**Warren Generating Station NPDES Permit No. PA0005053  
Conewango Township, Warren County  
Comments on Draft NPDES Permit**

GenOn REMA, LLC appreciates the opportunity to provide comments on draft NPDES Permit No. PA0005053 for Warren Generating Station that was published in the PA Bulletin on September 14, 2019.

**Proposed Peaker  
Subdivision Map**  
GenOn Divestiture - Warren  
October 2019

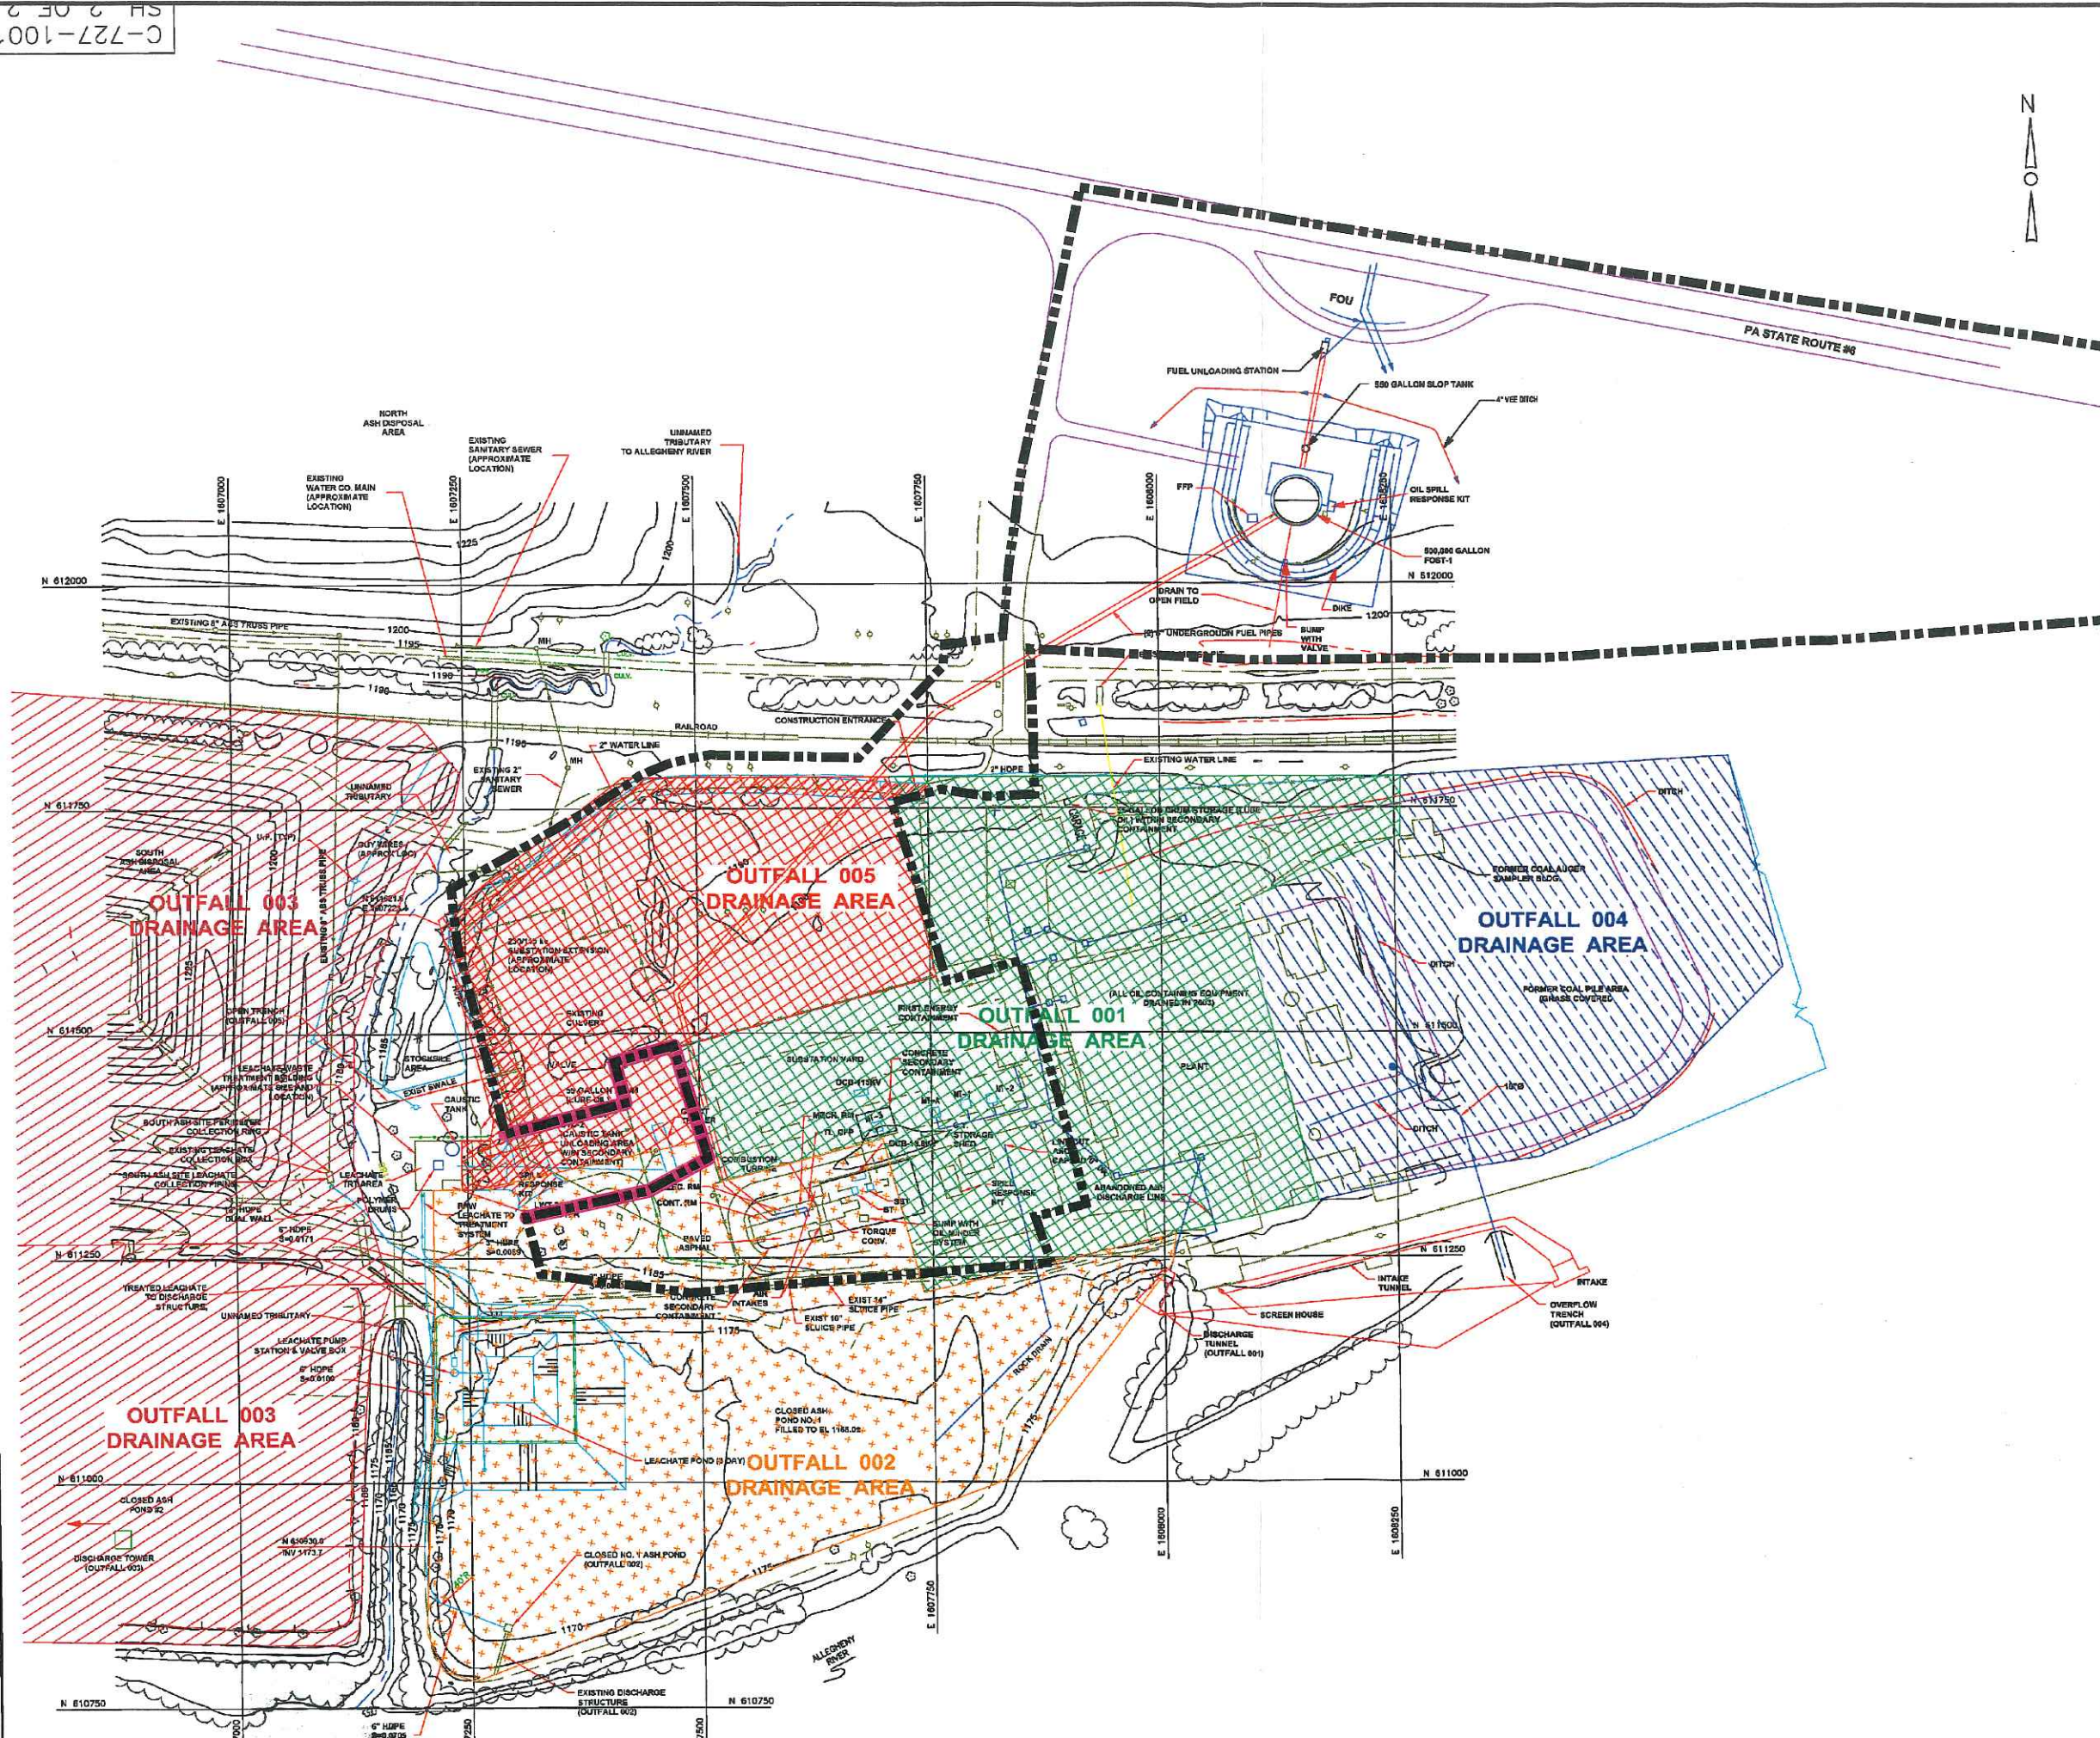
Subdivision Plan – As discussed in our call with you on September 25, 2019, GenOn plans to subdivide the Warren Station property to separate the Combustion Turbine (CT) site from the former coal-fired generating station site. A subdivision map is attached. The area within the cross-hatched black lines will fall under a permit to be issued to Warren Power, LLC. GenOn requests that the subdivided parcel be excluded from the NPDES permit and that this permit be held until permitting for the new parcel is in place.
